Planning Department Staff Analysis

N4. Case No: A-22-1245385

Project Name: 2784 and 2790 North Druid Hills Road- KENCO Apartments

Request: 1) Variance from Chapter 27-2.11.2- Dimensional Requirements to increase the maximum front setback from a major arterial road in MR-2 (Medium Density Residential-2) Zoning District from 20-feet to 26-feet.

**FRONT SETBACK
VARIANCE EXHIBIT**

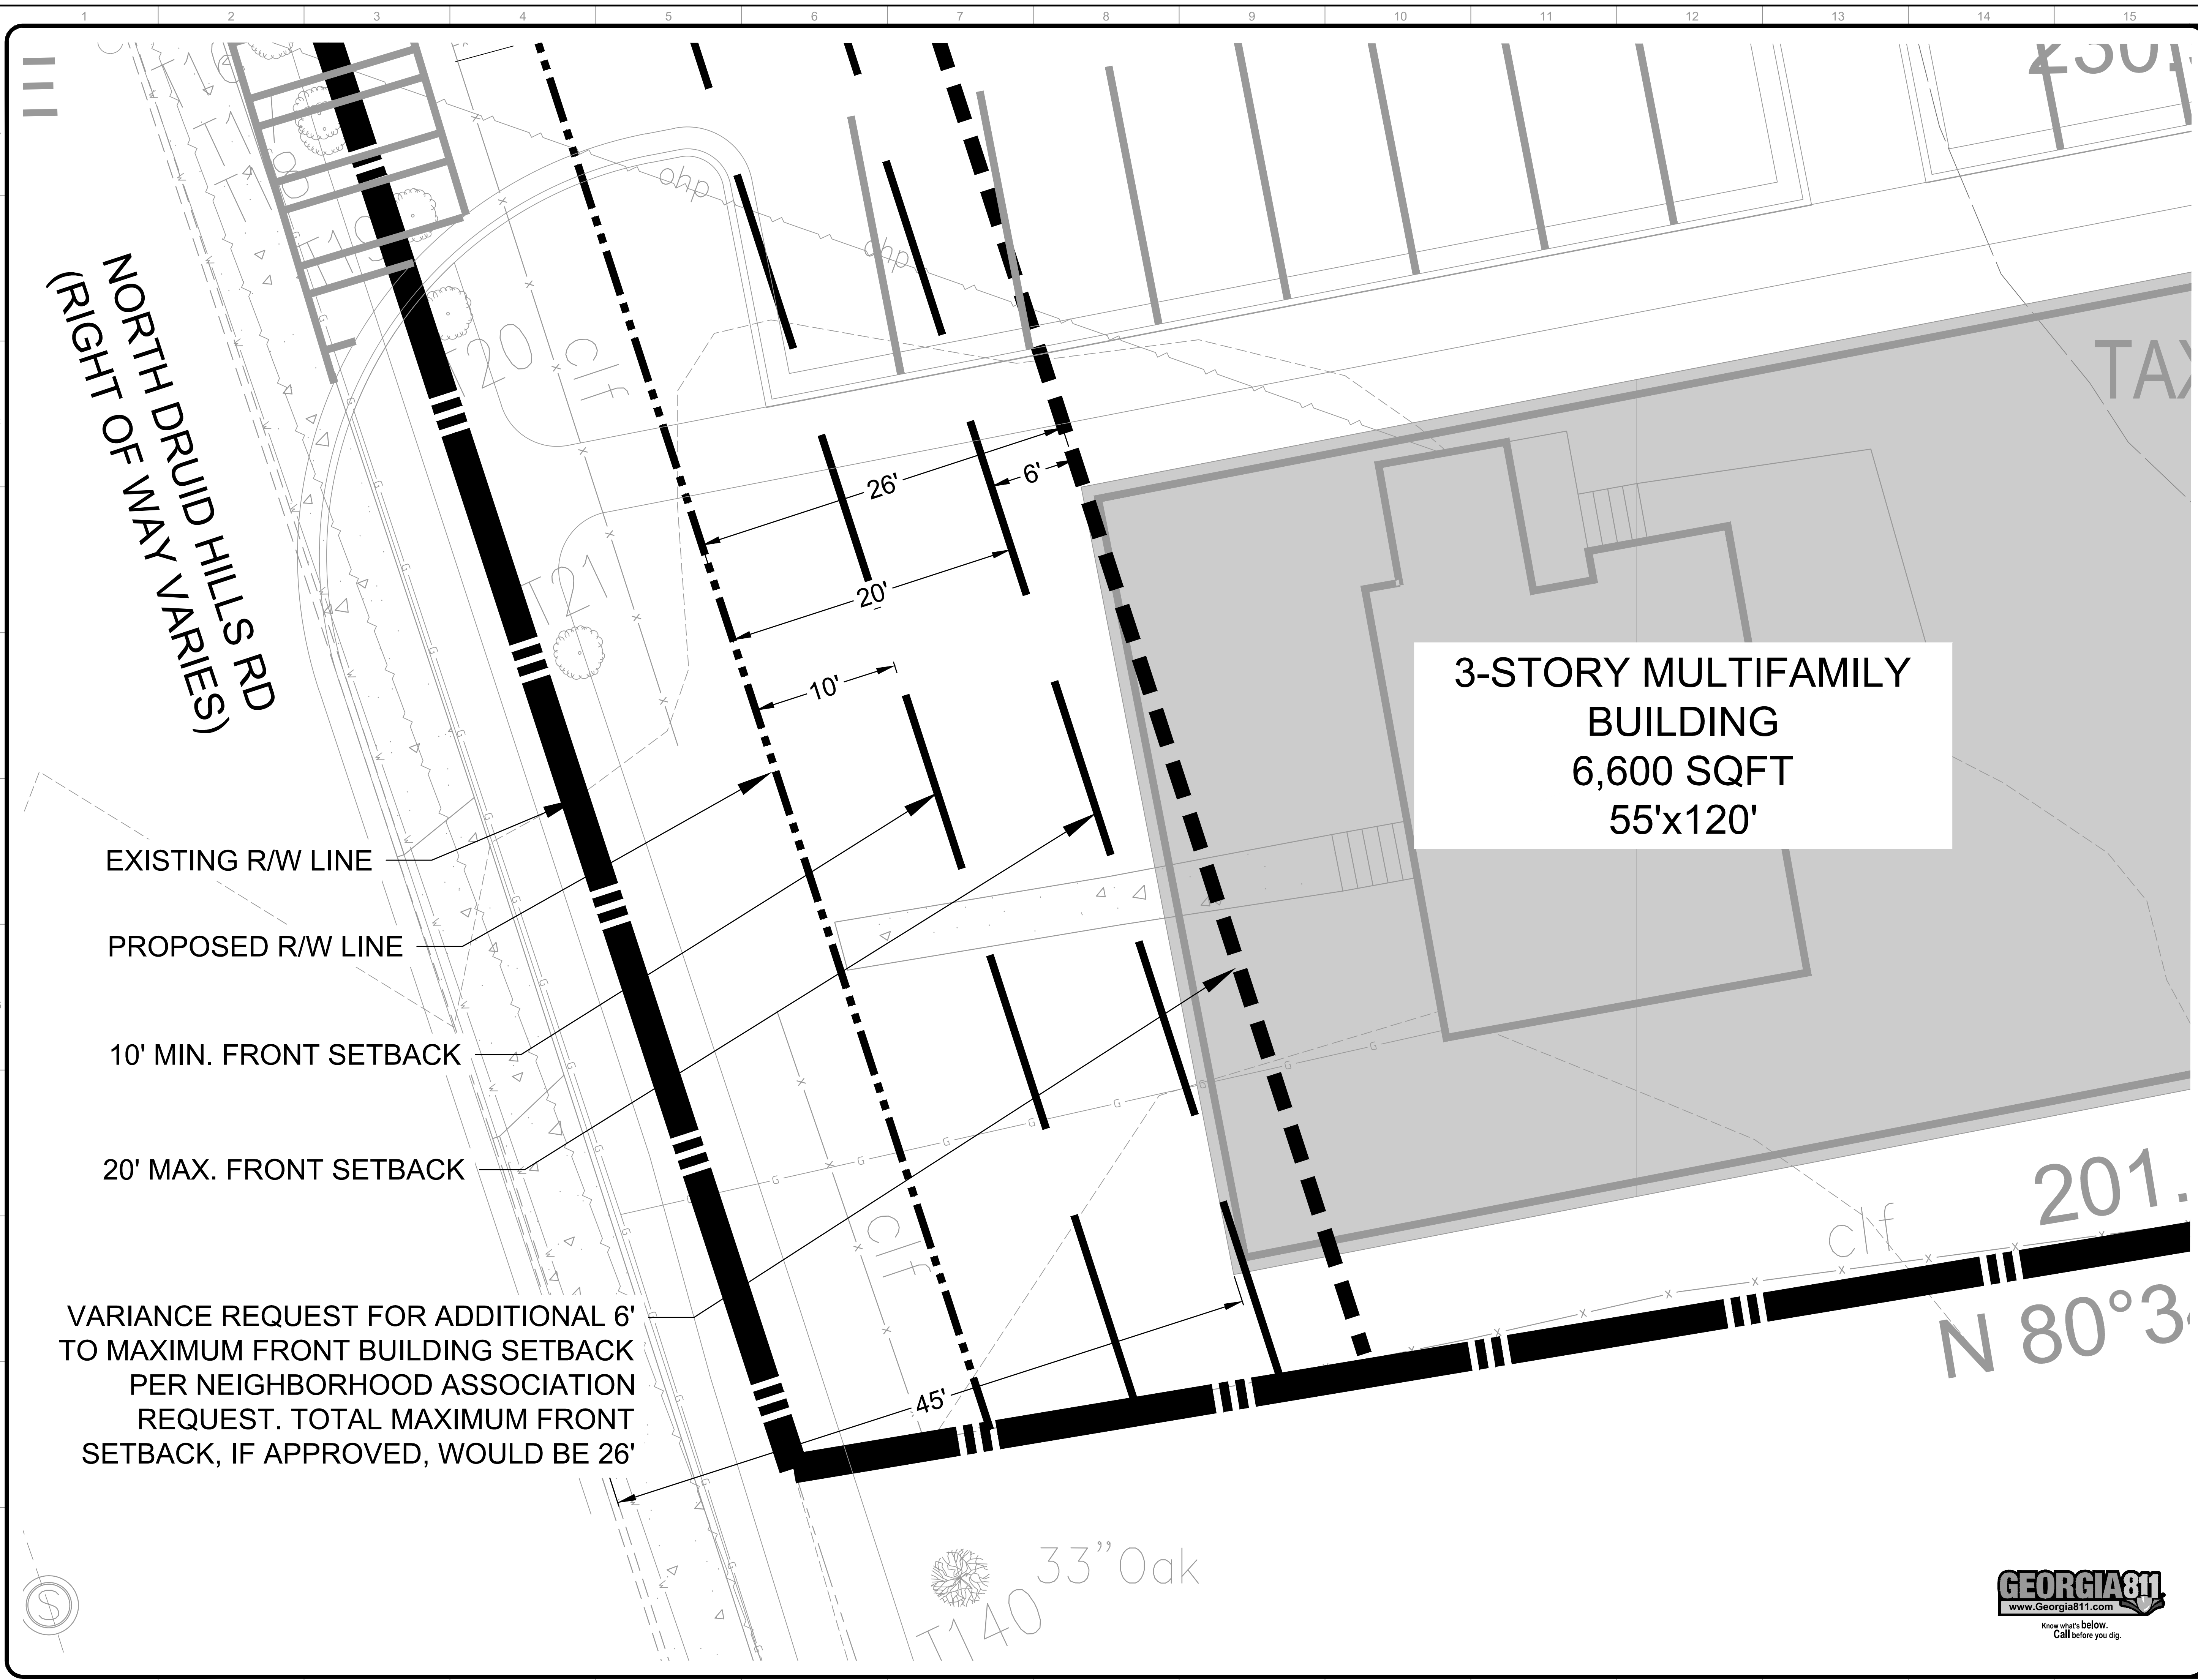
The maximum setback in the MR-2 Zoning District from an arterial road is 20-feet. The requested increase of the setback from 20-feet to 26-feet may be considered a modest degree of relief. This request is limited to only the northwest portion of the building.

Increasing the maximum setback by 6 feet may be consistent with the spirit and purpose of a Town Center designation because it does not significantly detract from the desire to create a more active, vibrant streetscape along with other benefits not subject to this variance request.

VARIANCE REQUEST FOR ADDITIONAL 6'
TO MAXIMUM FRONT BUILDING SETBACK
PER NEIGHBORHOOD ASSOCIATION
REQUEST. TOTAL MAXIMUM FRONT
SETBACK, IF APPROVED, WOULD BE 26'

- 1) Approval.
- 2) Approve with conditions:
 1. The transitional buffer shall be no less than 30-feet in any segment of the buffer and will be 50-feet or greater in the segments shown on the "Transitional Buffer Variance Exhibit" dated 08/04/2021.
 3. An 8-foot-tall wooden fence must be installed along the entire northern property boundary.
 4. The transitional buffer shall comply with the buffer planting and other requirements of [Chapter 27-5.4.5](#)
 5. The following information about these variances shall be noted on any site plan prepared for the subject property: case number, approval date, type of variance, and condition(s) of approval.

TRANSITIONAL BUFFER VARIANCE EXHIBIT

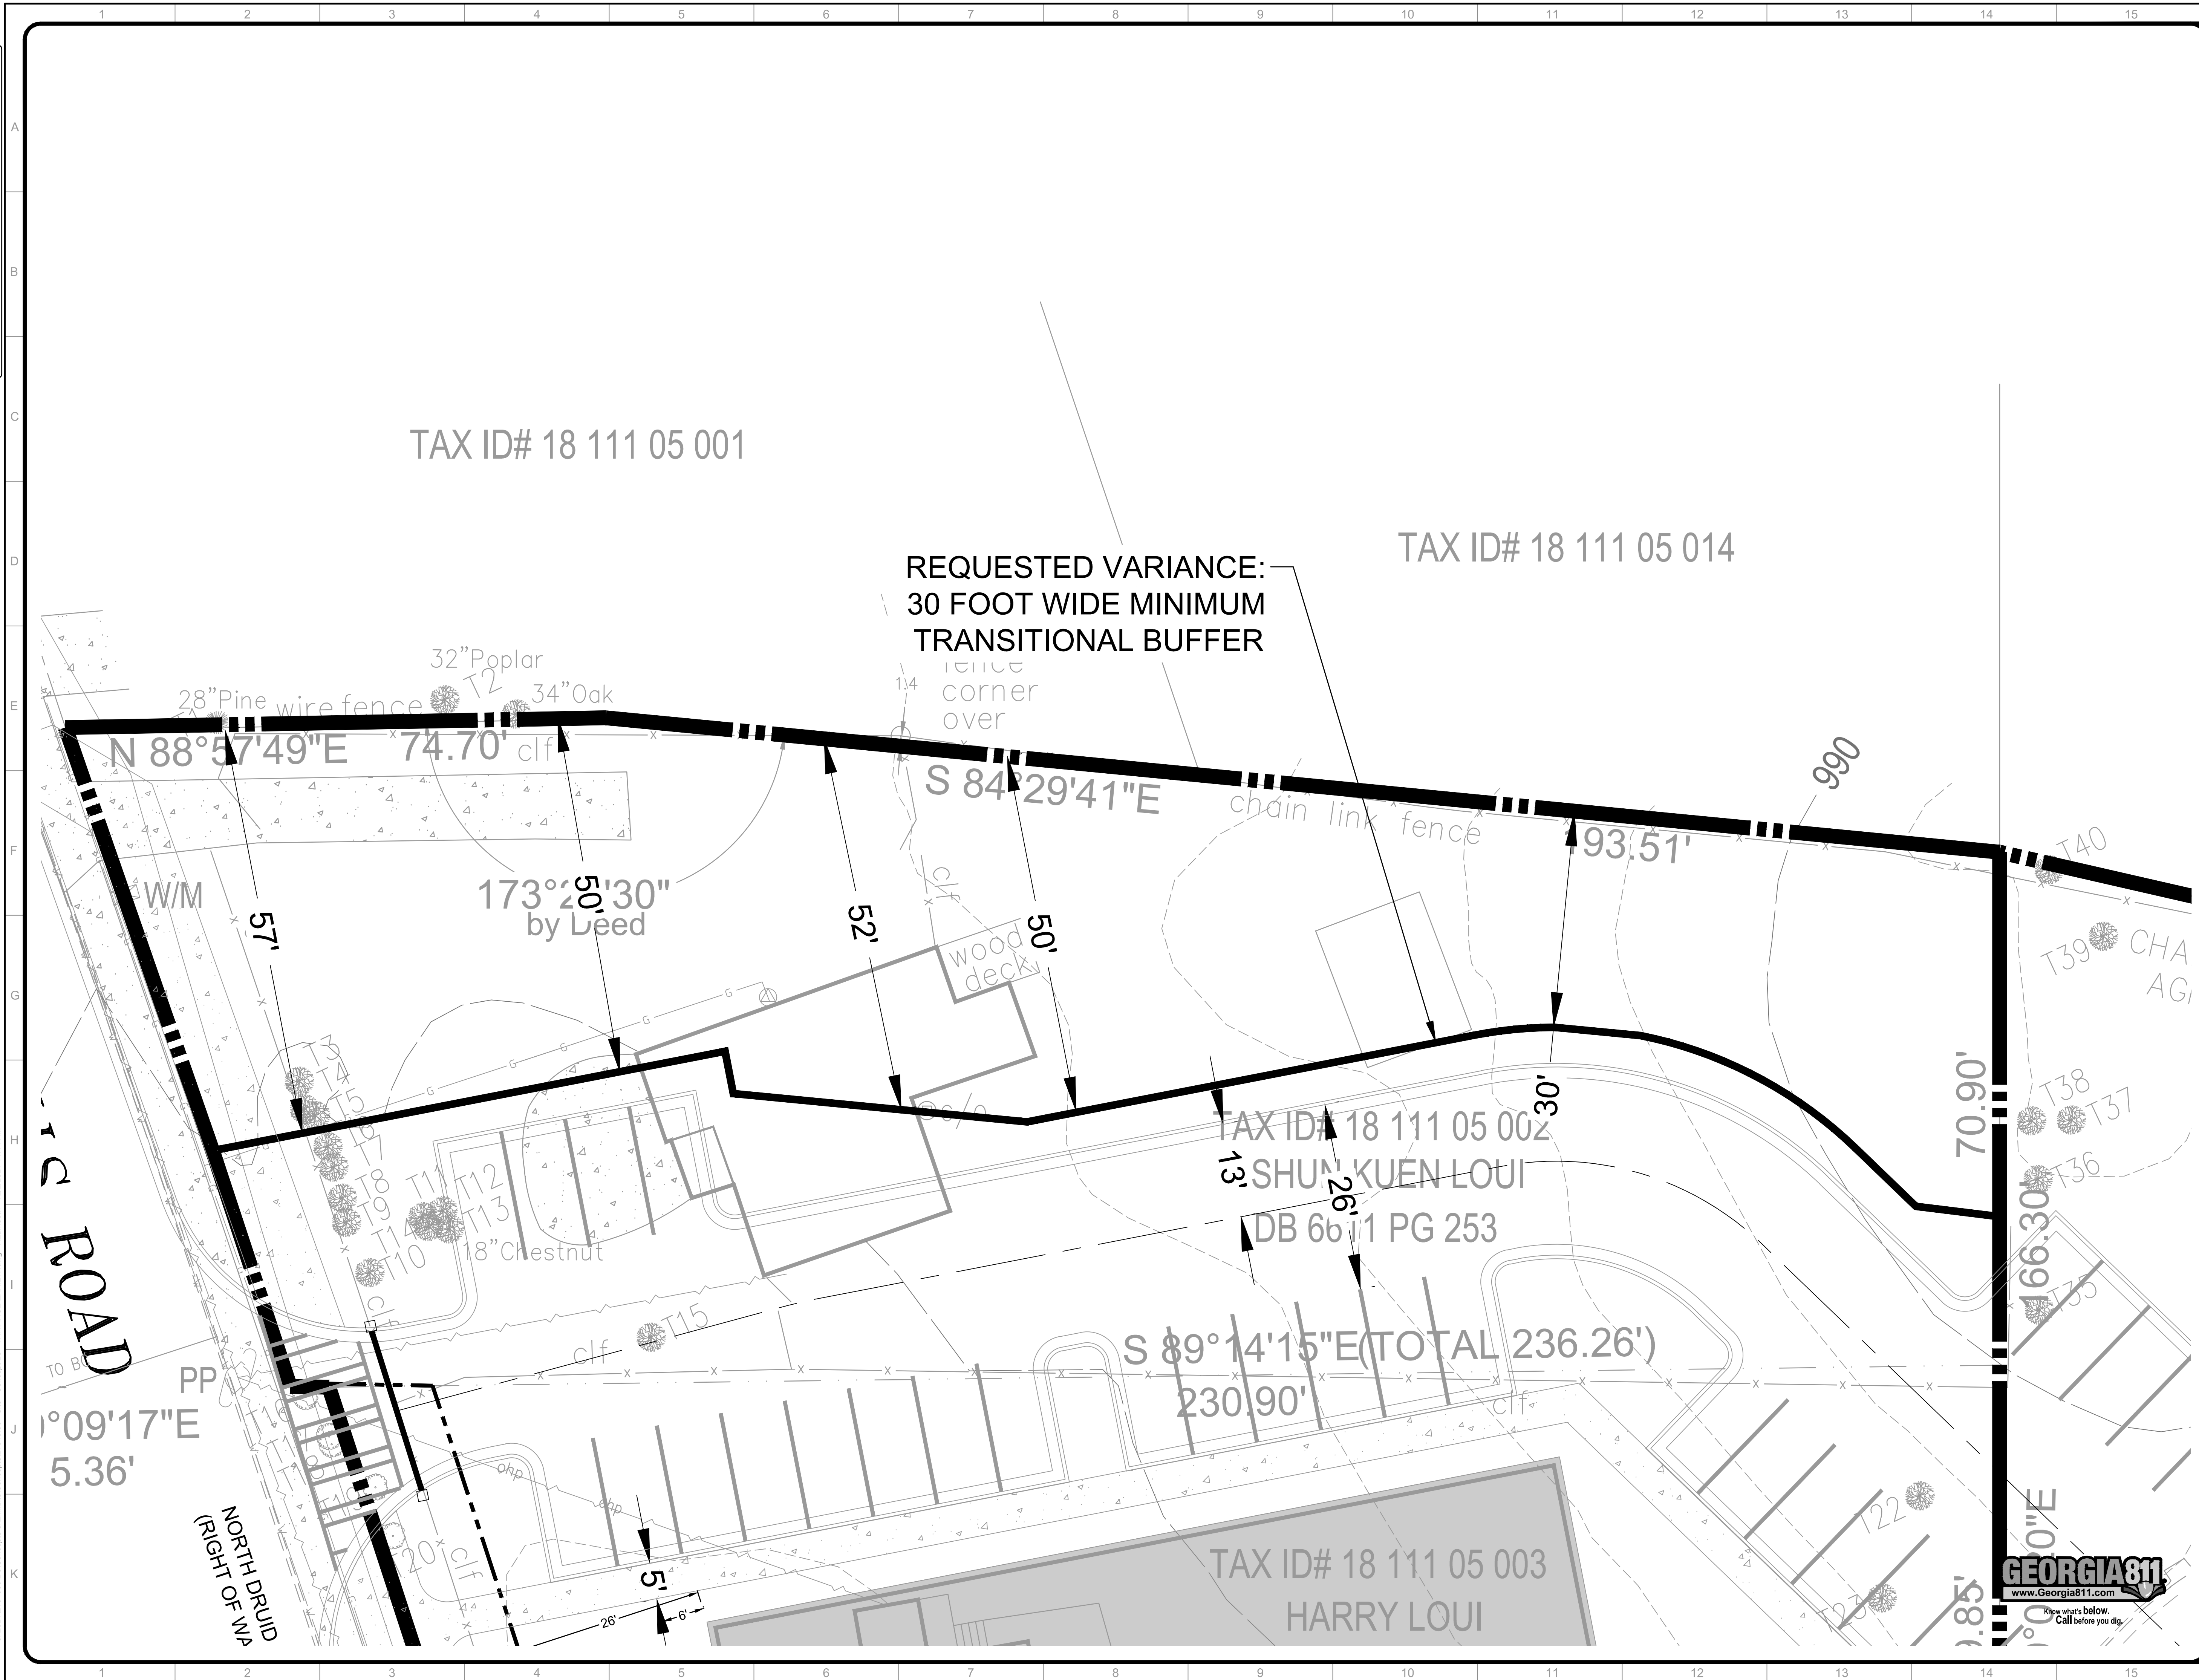
The requested reduction of a portion of the transitional buffer may not go beyond the minimum necessary to afford relief. The applicant has provided a wider than required buffer in other segments and is only requesting this decrease in a small section of the buffer.

Also, the reduction of the required transitional buffer may be consistent with the goals of the *Comprehensive Plan* to provide a vegetative transition between the more intense land uses within activity centers and established residential communities. Where possible, the buffer will exceed 50 feet. The buffer reduction will not be less than 30 feet at any point and the applicant proposes to install a fence and mature evergreen trees to accelerate the required buffer mitigation measures.

1) The reduction of the Transitional Buffer between your subject properties and the adjacent tax parcels 18-11-05-001 and 18-111-05-014 to the north.

In light of all these measures, which are stipulated among the approved Zoning Conditions, NDHRA does not see the encroachment of the curved segment of the driveway that is situated within the 50-foot transitional buffer as causing any significant adverse physical impact on the two aforementioned parcels to the north. Accordingly, NDHRA supports the requested reduction of the transitional buffer from 50 feet to not less than 30 feet, as indicated on the most recent site plans (Sheets Z1 and Z2, Revised 11/4/2021) submitted to the County along with the Zoning Conditions, dated November 16, 2021.

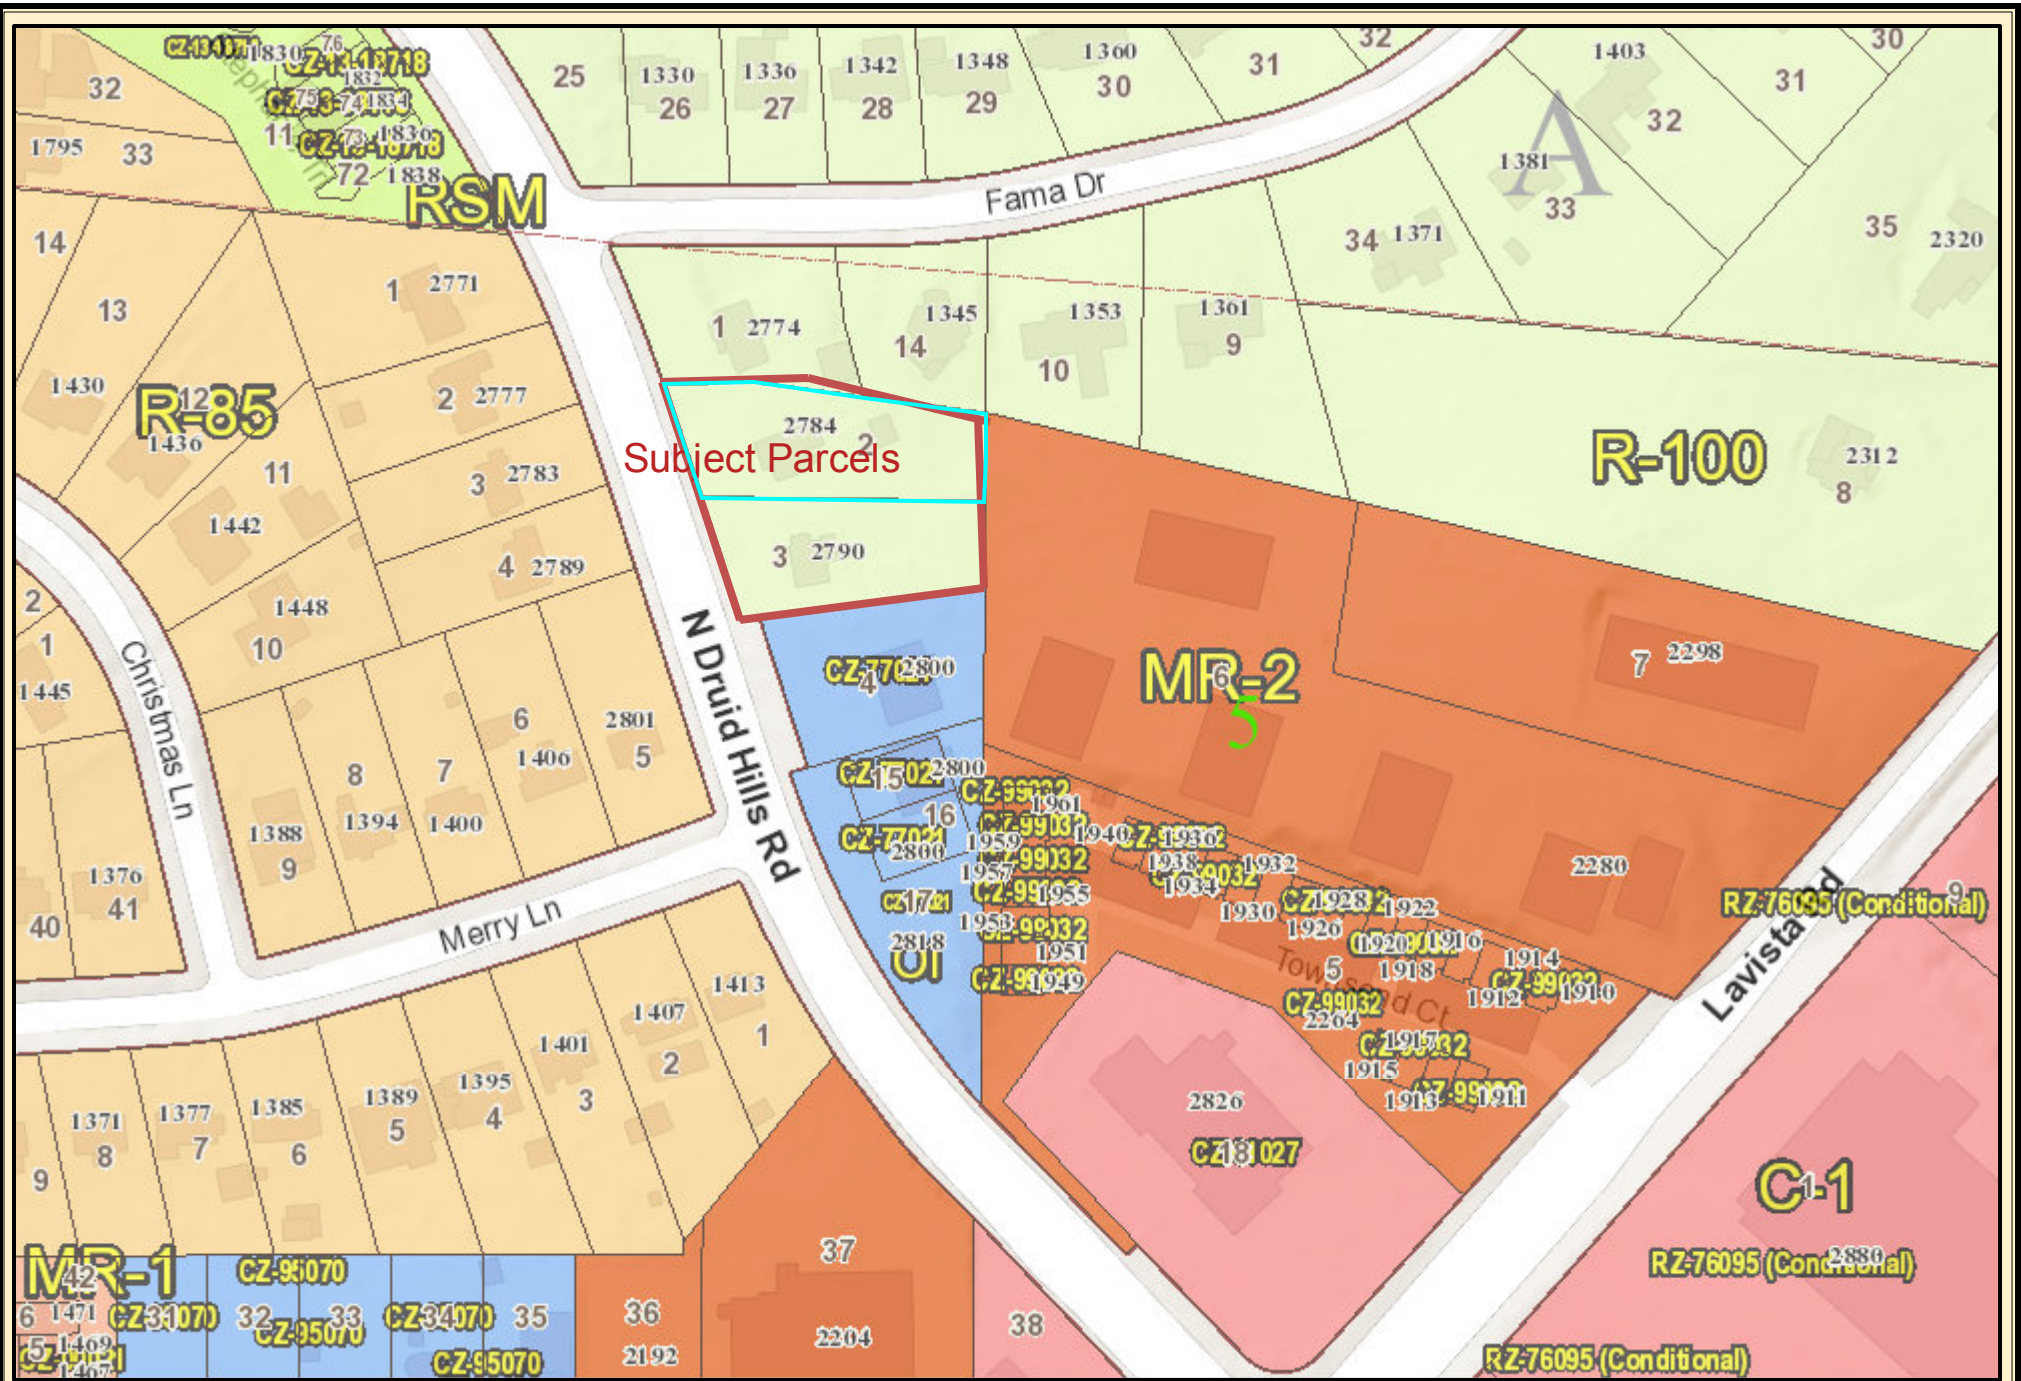
2) The new apartment building's setback from North Druid Hills Road.

From the very beginning of Kenco Residential's working with the neighborhood on this project in April 2021, the building's setback from North Druid Hills Road to the fullest extent possible was among our primary concerns. Accordingly, Kenco has agreed to abide by this request. The most recent site plans (Sheets Z1 and Z2, Revised 11/4/2021) indicate a stipulated setback of 45.01 feet, measured perpendicularly from the back-of-curb to the closest point of the building's southwest corner. Kenco Residential, NDHRA and the Fama Drive homeowners fully support this minimum setback from North Druid Hills Road.

Note that this setback will also facilitate the installation of the 6-foot landscape strip and 10-foot multi-purpose trail (sidewalk) along North Druid Hills Road, as well as a buffer for decorative landscaping between the new sidewalk and the new building that will include new hardwood trees.
